**DATE:** 10.18.2013  
**TO:** ProTrak  
**FROM:** Bill McDow  
 Transportation Planning

■ **VILLAGE AT COLLEGE AND OLEANDER US CELLULAR [Initial plan review]**

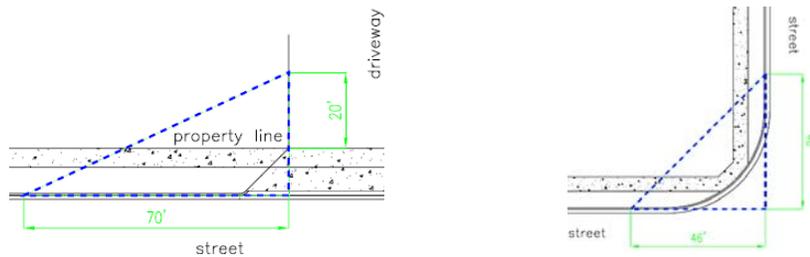
- ❖ Per the Institute of Transportation Engineers (ITE) Trip Generation 9<sup>th</sup> Edition, 2012, Microtrans Trip Generation Software; the estimated Trip Generation for the proposed Office/Retail (ITE land use code 715) is 30 total driveway volume in AM peak hours, 41 total driveway volume in the PM peak hours and 150 total average weekday 2-way driveway volume.
- ❖ A Traffic Impact Analysis (TIA) will not be required for this development if the above information is consistent with the proposed use. Contact Transportation Planning prior to resubmitting plans if the intended use of the site is different than what is outlined above.
